REVIEW OF FHWA REPORT ON THE FAILURES ON I-795
NEAR GOLDSBORO NORTH CAROLINA
(PRELIMINARY)

Richard E. Root, P.E.
Root Pavement Technology, Inc.

March 3, 2009

Figure 1

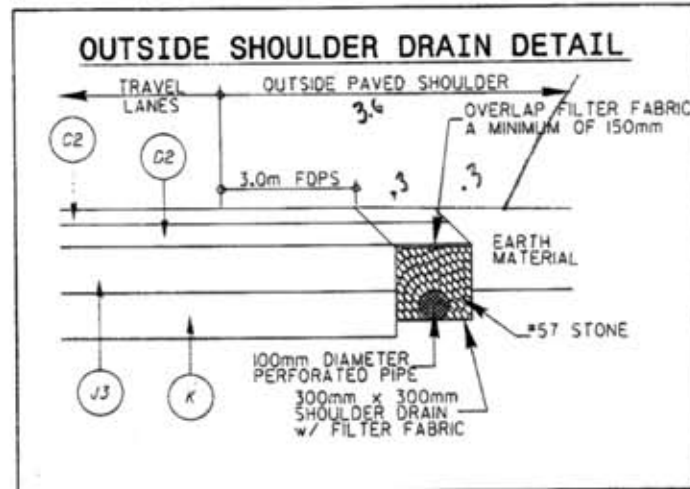
Pavement sections built without shoulder drains have a much greater chance for poor performance. This is demonstrated in NCDOT's plan detail drawing for shoulder drains for the South Section of the project (Figure 1). In the drawing, "K" represents the treated subgrade material and "J3" the 11 inches of ABC. The "earth material" shown to the right of the drain is a soil material intended to grow grass and resist erosion due to rainfall.

When the shoulder drain is not present, the "earth material" acts as a dam and holds the water in the pavement structure, creating a bathtub effect. Visual observation made during my February 2009 site visit indicates water standing and/or running in the ditches and woods near the areas of pavement failure. The possibility of trapped water in the pavement could explain the low strength values measured in the failed areas by the FWD testing.

Figure 20. SB I-795 pavement condition and HMA surface layer air-voids.

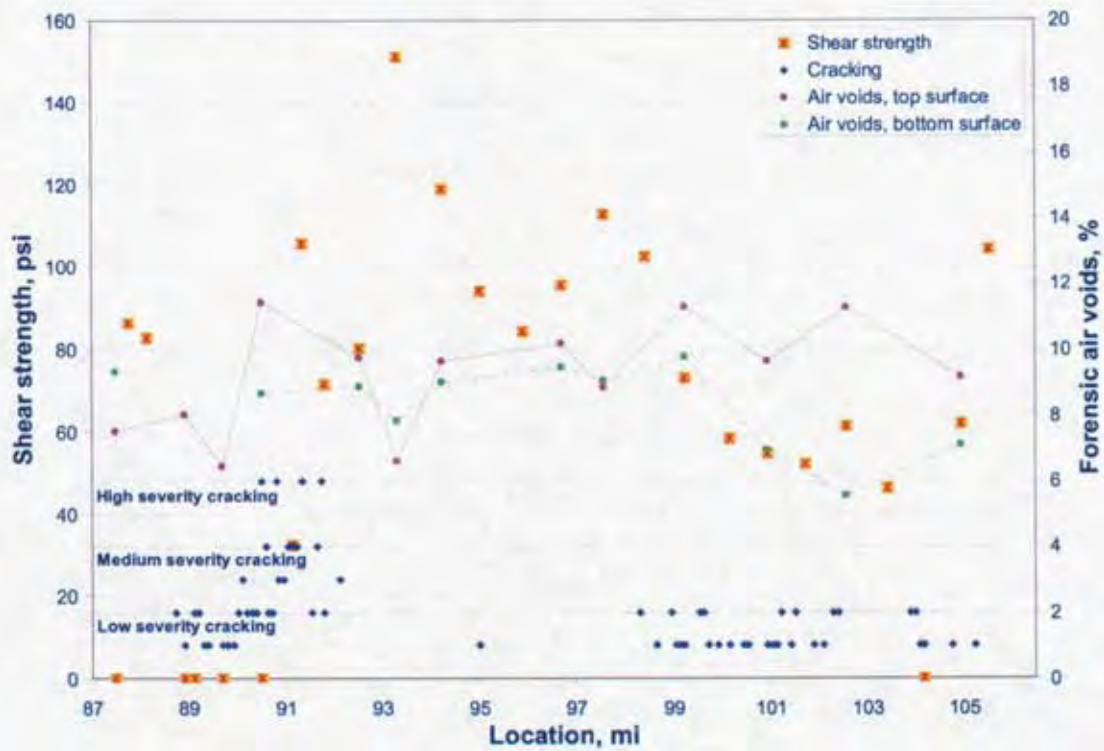
Comparison of First Forensic Air Voids to Pavement Performance - Figures 20 and 21 in the FHWA report (reproduced below), show that air voids have no relation to pavement performance. For the southbound lane (Figure 20), the “final surface” layer air voids are higher from MP 95 to MP 105, an area of no repairs when compared to the air voids at the south end of the project, where repairs were made. For the “first surface” layer from MP 95 to MP 105, some air voids are higher and some lower than the air voids in the repair areas at the south end of the project.

Figure 21. NB I-795 pavement condition and HMA surface layer air-voids.

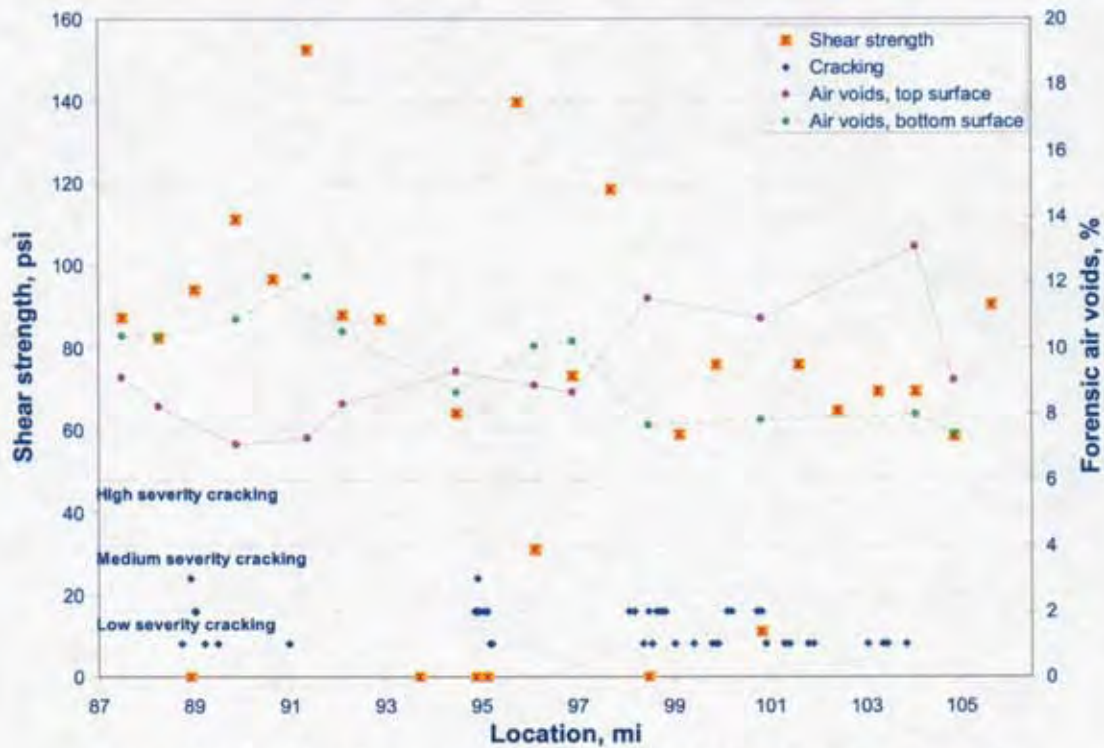
Results in the northbound lane are similar. The air voids in the “final surface” layer are significantly higher in the non-repair areas from MP 93 to MP105 compared to the south end of the project where the repairs were made. The air voids in the “first surface” layer are slightly

lower in the non-repair areas.

The FHWA premise that the pavement fatigue failures were primarily caused by high air voids in the surface layers is flawed. Based on the FHWA data, one would expect to have the same or more severe pavement failures at the north end of the project where the air voids are higher. This inconsistency, combined with the bias in the first forensic cores testing procedures and the results of the second forensic core study, leads to the conclusion that the air voids in the pavement surface layers did not contribute in any significant way to the limited pavement failures on the I-795 project.
